**ITEM 8. DEVELOPMENT APPLICATION: 620-632 BOTANY ROAD
ALEXANDRIA**

DEVELOPMENT APPLICATION NO: D/2015/364

Proposal Summary: Demolition of existing buildings and Stage 1 DA for a 6-storey mixed-use development with residential apartments, ground floor retail uses and parking, and basement parking with an FSR of 2:1 (15,184sqm).

Figure 22: Proposed site layout.

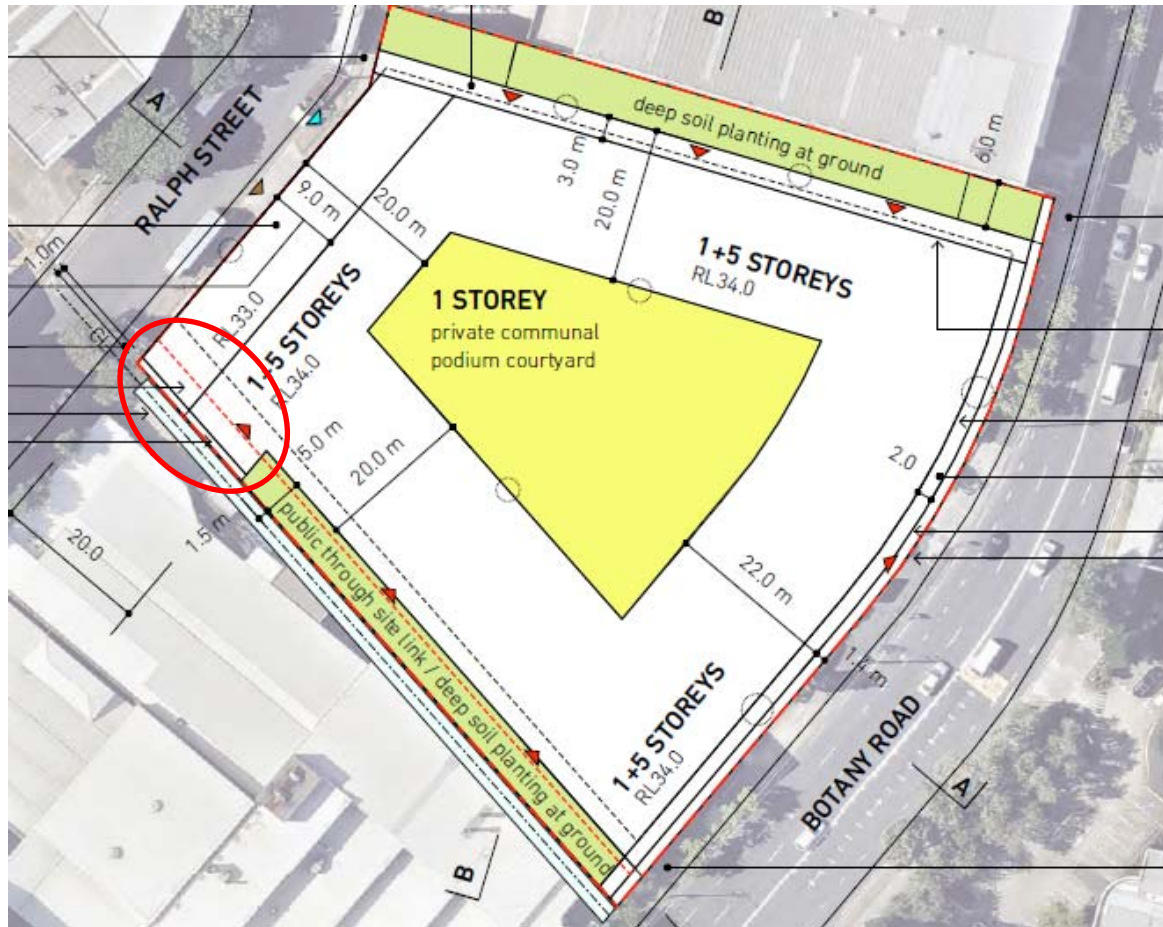
53. The application also proposes a wing extension above the through-site link for a length of 20 metres at the Ralph Street end of the south-western side boundary. This is setback 1 metre from the boundary in accordance with Sydney Water requirements for a setback from the adjoining channel. This is shown in Figure 22 below.

Figure 23: The Ralph Street elevation indicating the cantilevered building.

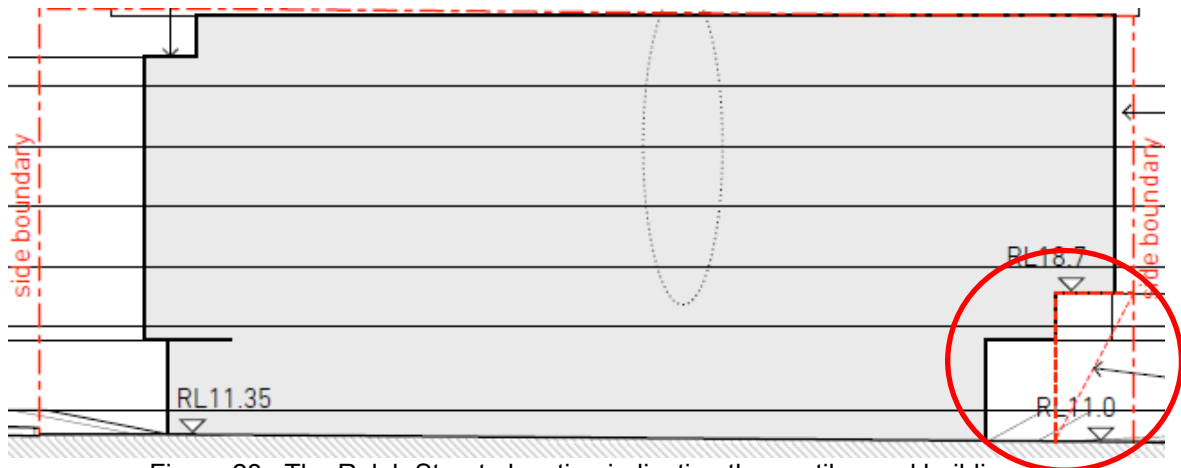
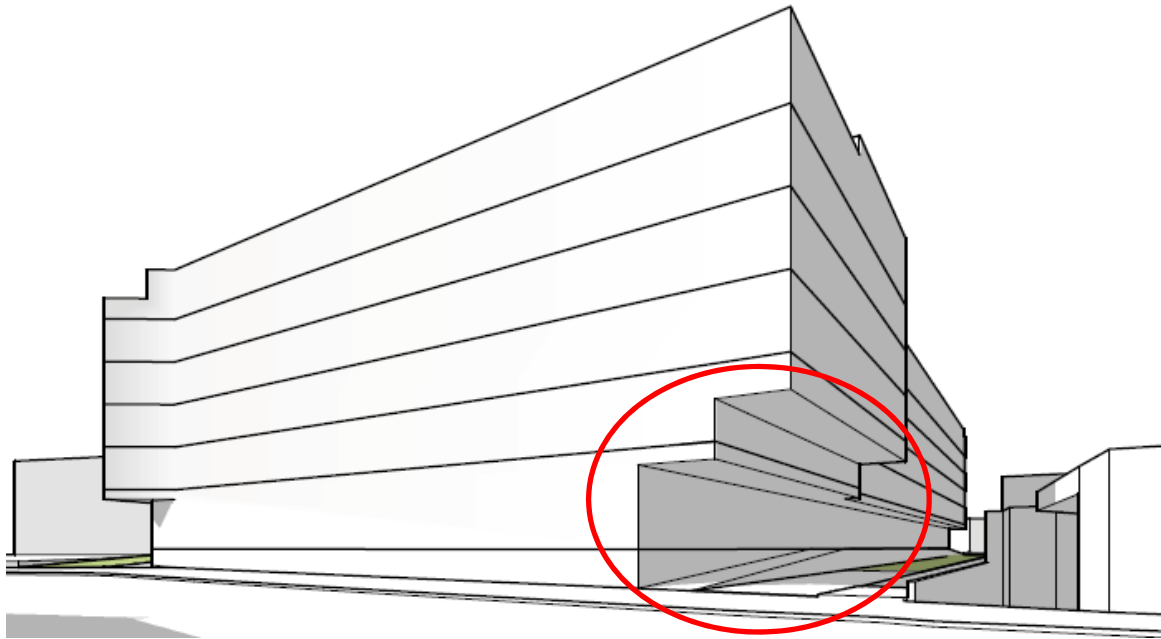
54. The ground floor level is setback 7.5 metres from the boundary and the wing extension is proposed to be cantilevered 6.5 metres in total, comprising of:
- (a) a 3 metre wide section over the through-site link, with a 7.7 metre vertical clearance to the through site link; and
 - (b) a further 3.5 metre wide section with a 5 metre vertical clearance.
55. This is shown in Figures 23 and 24 below.

56. In this instance it is considered that a cantilevered building design of 6.5 metres in width is not acceptable and an inefficient building design due to the slab thickness required to successfully cantilever a building of this size. Columns that would be required to support the structure would be intrusive elements within the through-site link.
57. Therefore a condition is recommended that the building be setback 5 metres from the side boundary which will ensure that the side setback is consistent for the length of the building. This condition will also ensure that the through-site link is open to the sky as much as practicable in accordance with Section 3.1.2.2(4) of the Sydney DCP 2012.

Figure 25: A section through the proposal which indicates the potential development of neighbouring properties (indicated by a dotted line).

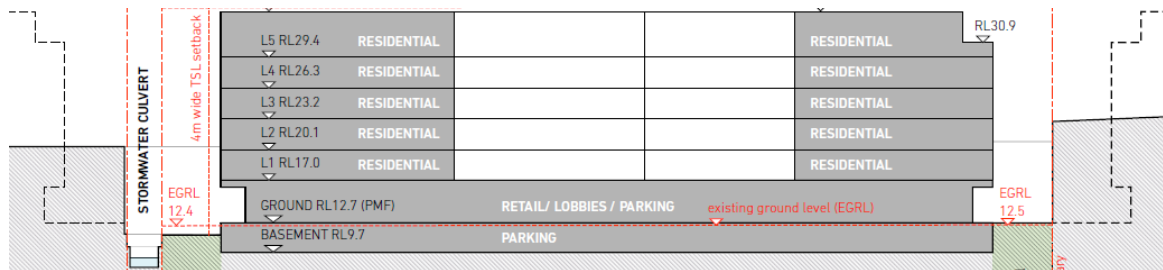
61. The application has considered the potential future development of neighbouring sites as indicated by the dotted lines in Figure 25 below.
62. If the proposed side setbacks are mirrored on the neighbouring developments a 12 metre setback will be achieved with the site to the north, and a 13 metre setback achieved with the site to the south. Whilst levels 5 and 6 will not achieve the building separations between habitable rooms recommended by the ADG, this is considered to be acceptable as this can be addressed through the location of non-habitable rooms and other privacy measures at the detailed design stage.
